## ABS WARNING LAMP ILLUMINATES INTERMITTENTLY 1993 (LH) CHRYSLER CONCORD. DODGE INTREPID, EAGLE VISION

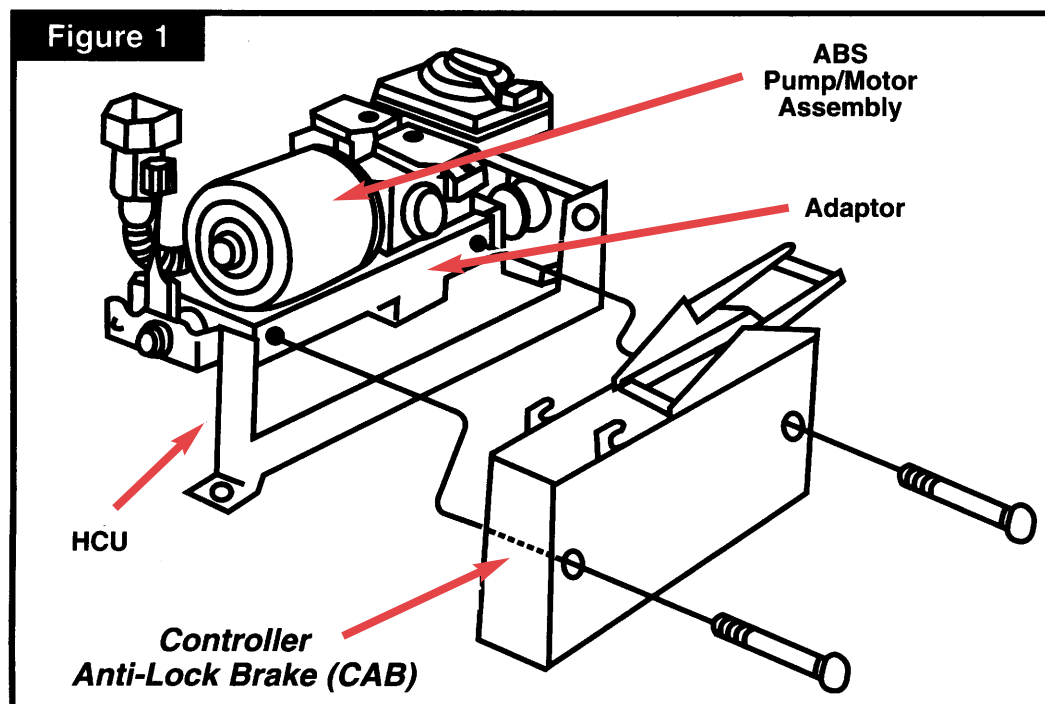
Electrical “noise” created by some combination of accessories may cause the ABS amber warning lamp to illuminate intermittently, even though there is actually no problem with the Teves Mark IV anti-lock brake system.

The Controller-Anti-Lock Brake (CAB) aluminum adaptor (see Fig. 1) must be replaced with a polyamid/plastic adaptor and an adhesive patch must be installed (see Fig. 2).

If an aluminum adaptor is present between the CAB and the housing of the Hydraulic Control Unit (HCU), it must be replaced with the appropriate kit. If the polyamid adaptor is already present, proceed to step 17.

8. Install the adhesive patch on the HCU side of the CAB as shown in Figure 2.
9. Remove the aluminum adaptor block between the HCU and the CAB. Two T30 torx head bolts hold the adaptor to the HCU.

10. Replace the aluminum adaptor with the polyamid adaptor along with the two new bolts in the kit (female indentations in the adaptor mate to the male nibs on the HCU). Torque the two bolts to 10-14 Nm (88-124 in. lbs.)
